MODEL 14
(Codes 122 & 123)

Replacement Parts for Model 14

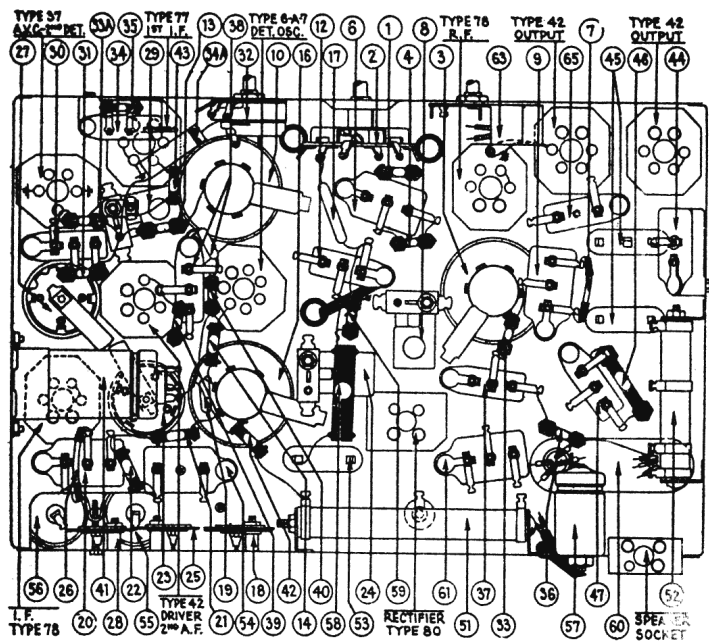
NOTE 1: In code 122 starting with run No. 5, condensers 55 and 57 are replaced by one condenser, part No. 30-2045, capacity 8 Mfd. and 10 Mfd.

NOTE 2: Starting with run No. 2, condenser 3903Z (.01 Mfd.) is superseded by No. 4989AJ (.09 Mfd.).

NOTE 3: Starting with run No. 2, resistor No. 4411 (.1 Meg.) is superseded by part 4517 (.5 Meg.).
